SB-24-10002

Title: Moving 2 in Venturi Valve to Inlet of Venturi

Product Line: Spray Tender

Model: Quickdraw 3000

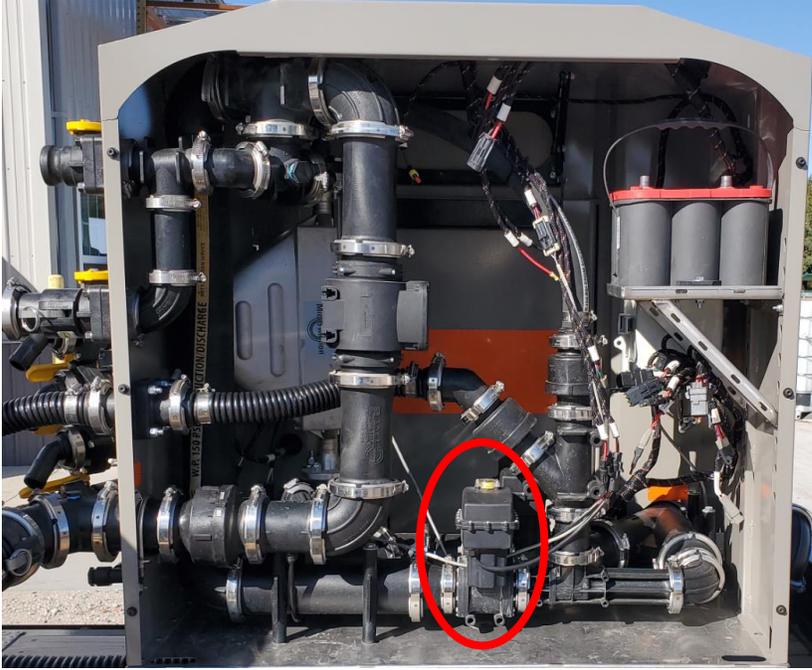
Change 1.25" suction hose to longer length.

Move 2" valve, currently after the venturi to opposite side of venturi (inlet).

Picture shows modified plumbing. Note the new valve and venturi location.
